Model: Model C-P2		Date: 12-Jan-05	No.: MG112001
Modified Article: Parts catalog correction: Choke Coil		Prepared by: A. Ishiyama	
From: 1st Technical Support Sec. Service Support Dept.			
Reason for Modification:	<input checked="" type="checkbox"/> Parts catalog correction <input type="checkbox"/> To facilitate assembly <input type="checkbox"/> Part standardization	<input type="checkbox"/> Vendor change <input type="checkbox"/> To improve reliability <input type="checkbox"/> Other	<input type="checkbox"/> To meet standards ()
Modification Schedule:	From first mass production.

Part Change Information List

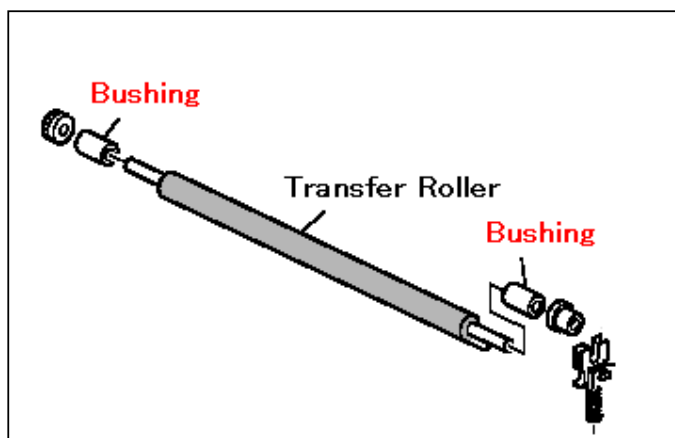
Incorrect Part Number	Correct Part Number	Description	Q'ty	Int	Page	Index	Note
G0965205	G1295205	Choke Coil	1→1	O/O	25	17

Reason:

1. Change of the materials used in the part in accordance with environmental restrictions.

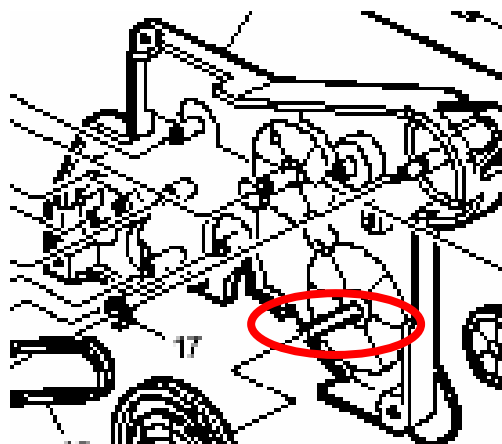
Old Part Number	New Part Number	Description	Q'ty	Int	Page	Index	Note
G0521102	M0011122	Drive Unit Bracket	1→1		23	2

Change: The material of the shaft was changed.

Reason: To further improve the performance of the drum drive mechanism.
